**MEMORANDUM**

**PROJECT:** Dale Drive Sidewalk  
From Mansfield Road to Hartford Avenue  
CIP No. 509036

**REVIEW TYPE:** Mandatory Referral No. 05810-DPW&T-1

**RECOMMENDATION: APPROVAL WITH COMMENTS TO DEPARTMENT OF PUBLIC WORKS AND TRANSPORTATION.**

Attachment 6

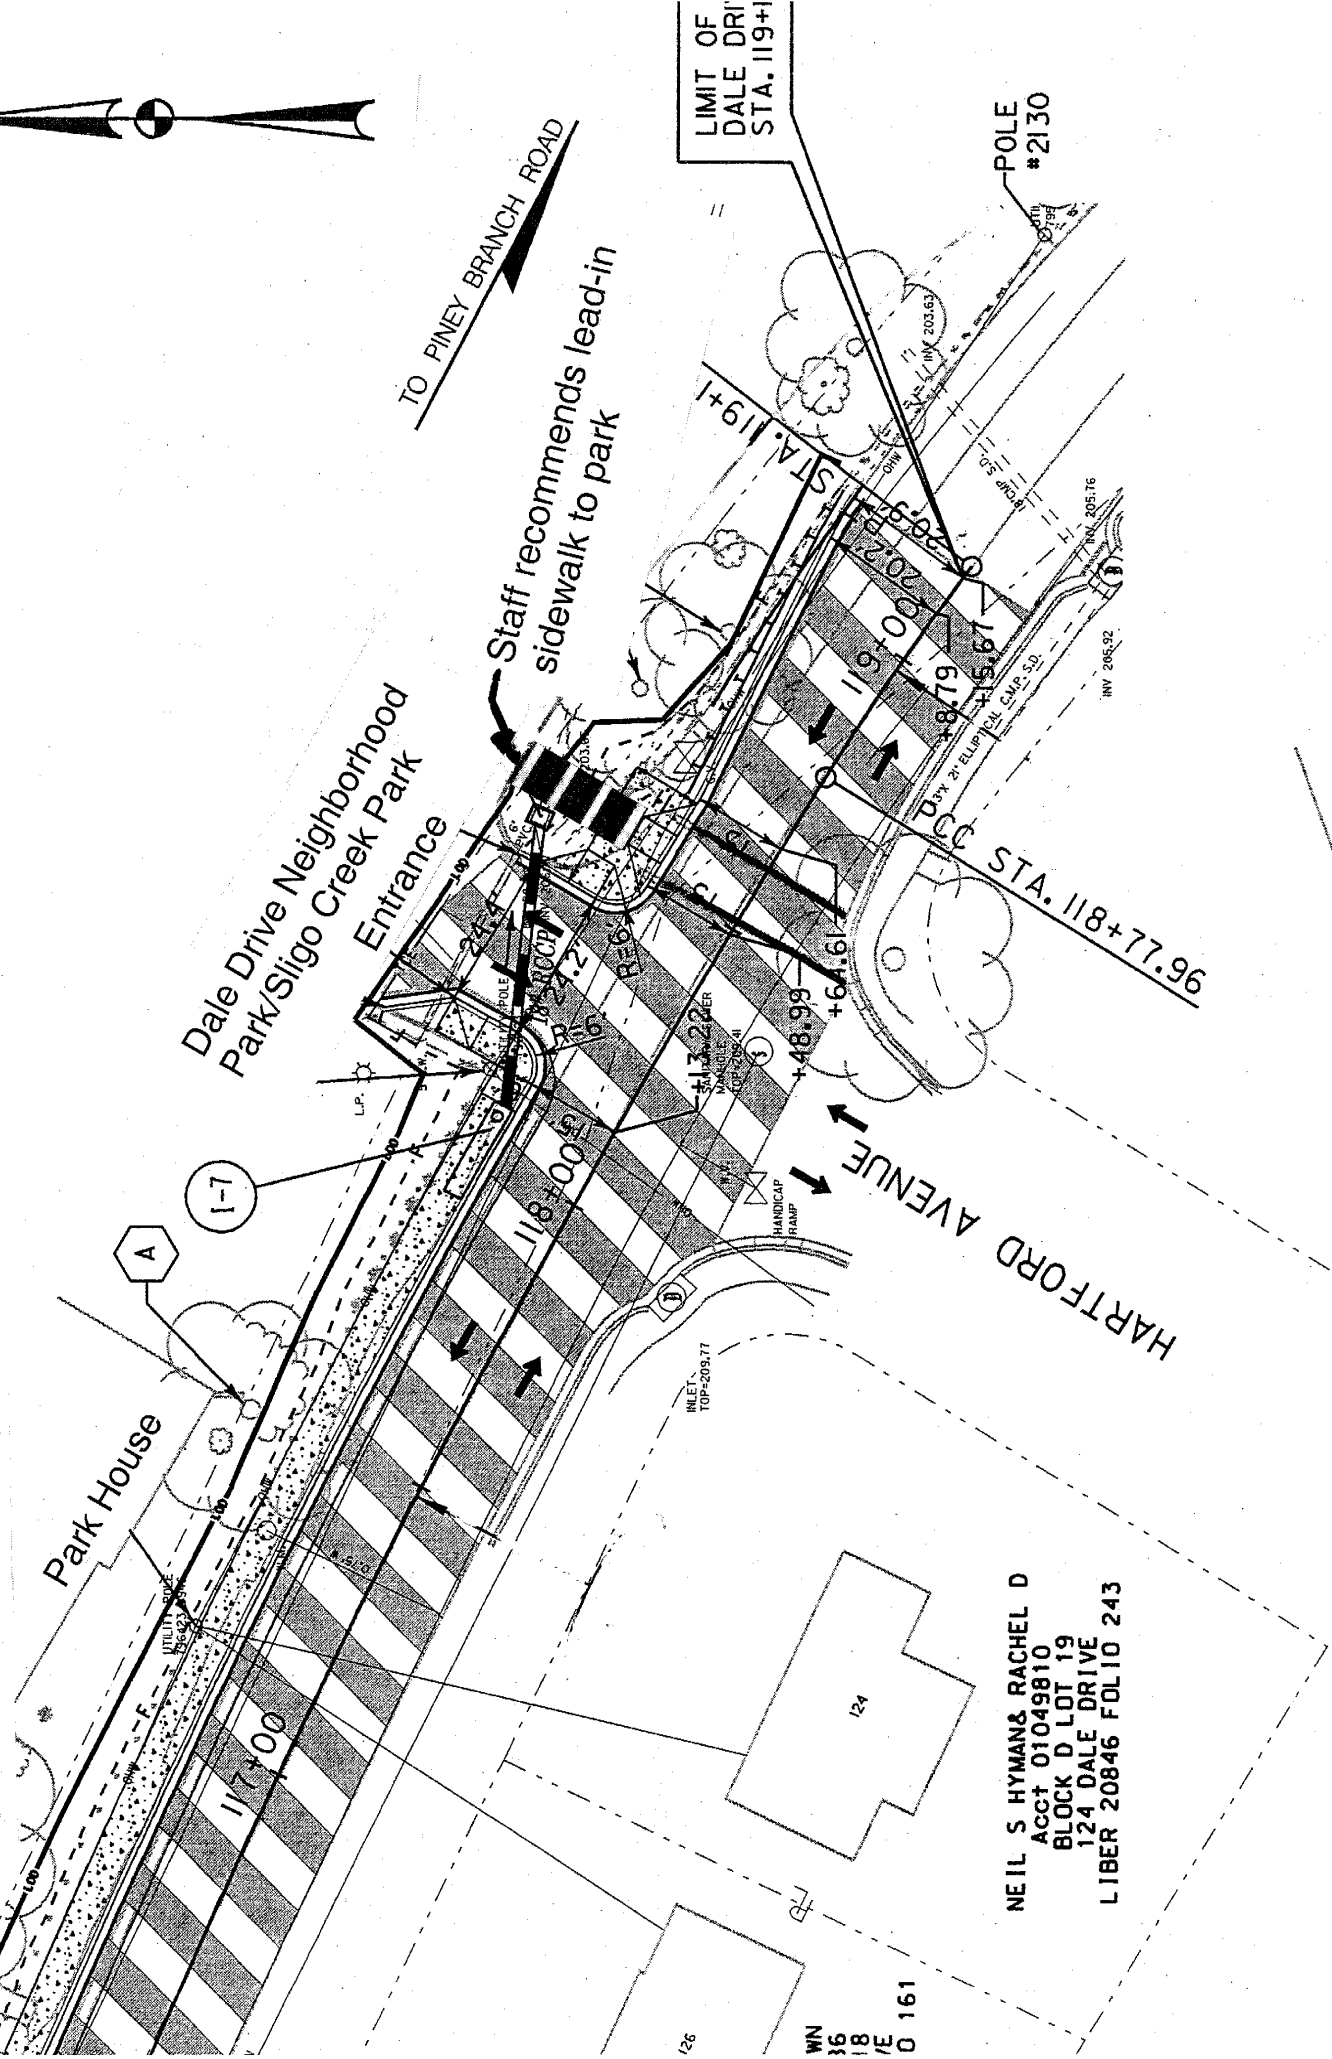
3. No staging and no storage of materials and/or equipment will be allowed on Park property without the prior approval from Park Inspector.
4. Provide a handrail along the proposed sidewalk near the top of the culvert headwall on park property opposite Galveston Street.

5. Access to the park driveway and the park house must be maintained at all times.
6. Provide a lead-in sidewalk on the east side of the park driveway. Minimize the slopework in this area and shorten the guardrail if possible.

Opposite Galveston Street, there is an existing 36-inch culvert that empties into the park with a fairly steep drop-off. *Staff recommends that a handrail be provided at the top of the slope to protect pedestrians on the proposed sidewalk from the drop-off.*

*Staff recommends that a lead-in sidewalk be provided on the east side of the driveway so that pedestrians walking between the sidewalk and the park do not have to walk in the throat of the driveway* (see Attachment 6). Staff also recommends that the slopework on the east side of the driveway be minimized and that the guardrail be shortened if possible.

Provide a handrail at the top of slope between the proposed sidewalk and the culvert.
